## Access Compliance Report Public Rights-of-Way (Curb Ramps)

Intersection ID: 9489 Main Street: STATESVILLE\_AV Cross Street: KOHLER\_AV Location: SE

ADA ID: D7A1BC91CB86 Ramp Type: Perp Initial Pass/Fail: Fail Overall Compliance: No Severity Score: 30

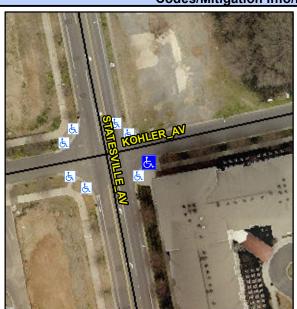
R304.5.1, R304.5.3

Field Measurements/Component Compliance					
Compliance Description		Data	Compliance Description		Data
N/A	Ramp Length (in)	94.5	Yes	Ramp Slope (%)	6.5
No	Ramp Width (in)	35.0	No	Ramp XSlope (%)	6.6
N/A	Flare Type LT	N/A	N/A	Flare Type RT	N/A
N/A	Flare Slope LT (%)	N/A	N/A	Flare Slope RT (%)	N/A
N/A	Flare Traversable LT?	N/A	N/A	Flare Traversable RT?	N/A
N/A	Landing Length (in)	N/A	N/A	DWS Provided?	N/A
N/A	Landing Width (in)	N/A	N/A	DWS Contrast?	N/A
N/A	Landing Slope (%)	N/A	N/A	DWS Length (in)	N/A
N/A	Landing X Slope (%)	N/A	N/A	DWS Full Width?	N/A
N/A	Landing Curb? (Y/N)	N/A	N/A	DWS Offset (in)	N/A
N/A	Shared Landing?	N/A			
N/A	Gutter Ponding?	N/A	N/A	Gutter Slope (%)	N/A
N/A	Gutter Lip Ht (in)	N/A	N/A	Gutter X Slope (%)	N/A
N/A	Painted X Walk1?	No	N/A	Painted X Walk2?	N/A
	X Walk 1 Direction	To NW		X Walk 2 Direction	N/A
N/A	X Walk 1 Width (in)	N/A	N/A	X Walk 2 Width (in)	N/A
	X Walk 1 Slope (%)	1.1		X Walk 2 Slope (%)	N/A

Remove & Replace Entire Ramp.
